# Interior Only Permit

# ORIGIN'S TENANT IMPROVEMENT AND CHANGE OF USE

**Development Services Center**  
Reviewed for Code Compliance

1 SITE PLAN  
1"=8'-0"

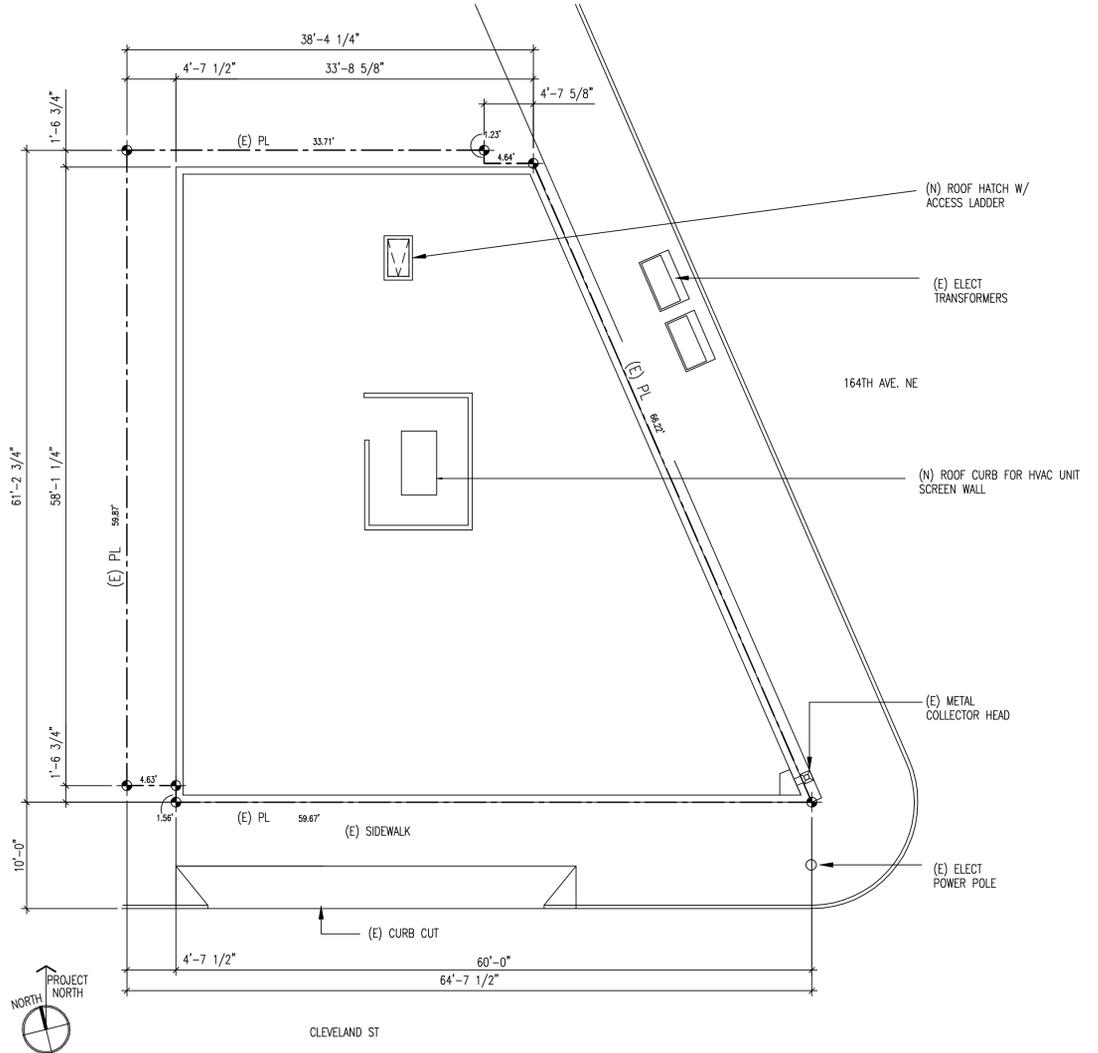
PL: Exterior modifications are not to be included within this permit

1 SOUTH ELEVATION  
1/4"=1'-0"

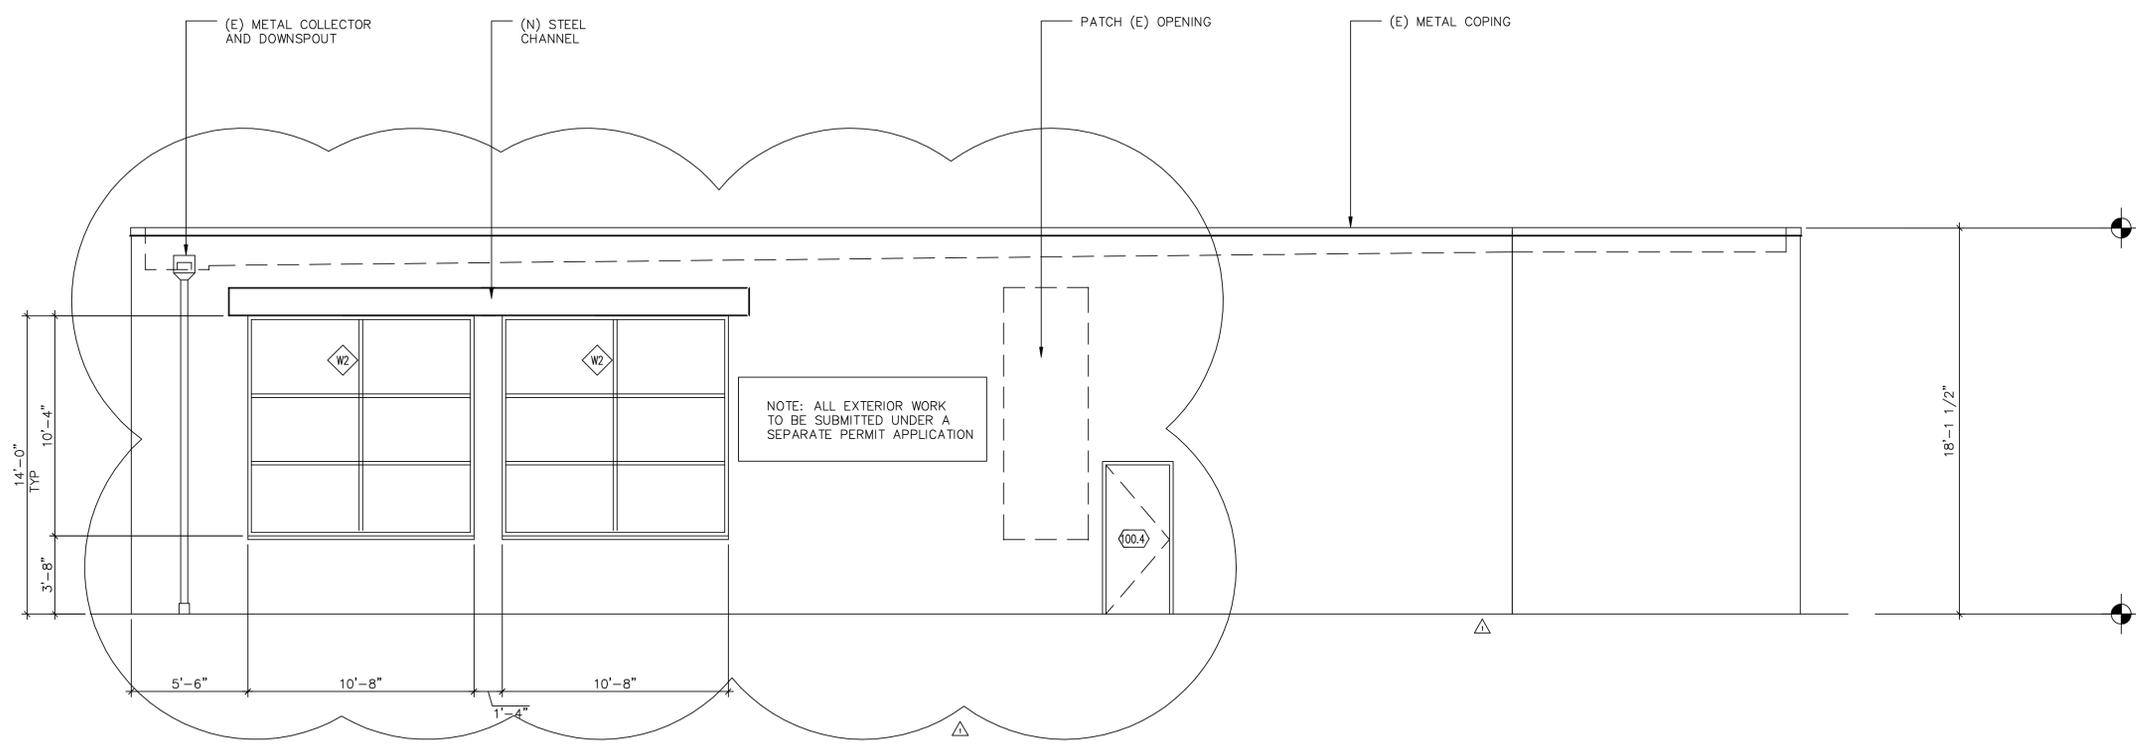
PL: Exterior modifications are not a part of this permit. Exterior alterations will likely be required to go through the Design Review Board

2 EAST ELEVATION  
1/4"=1'-0"

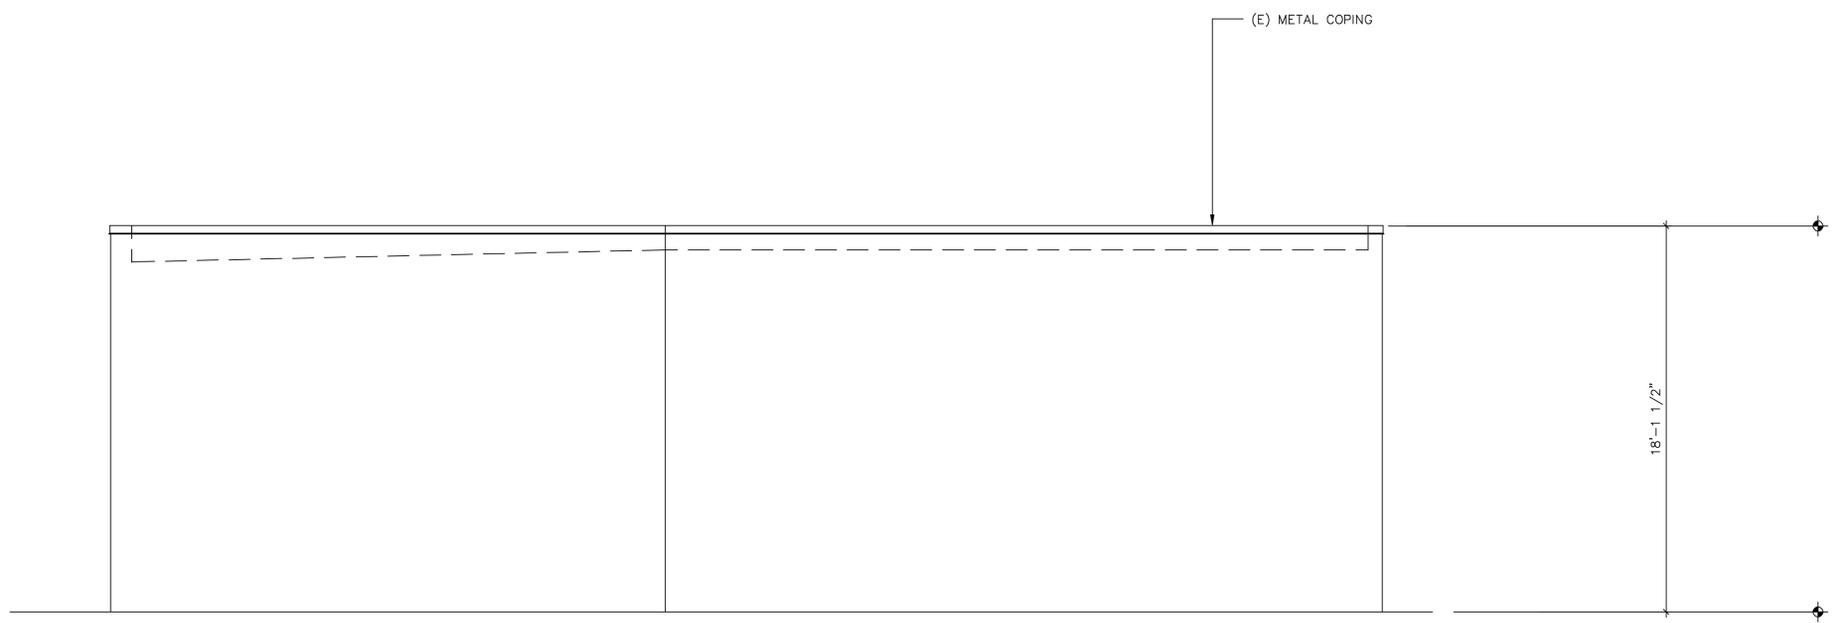
PL: Exterior modifications are not a part of this permit. Exterior alterations will likely be required to go through the Design Review Board
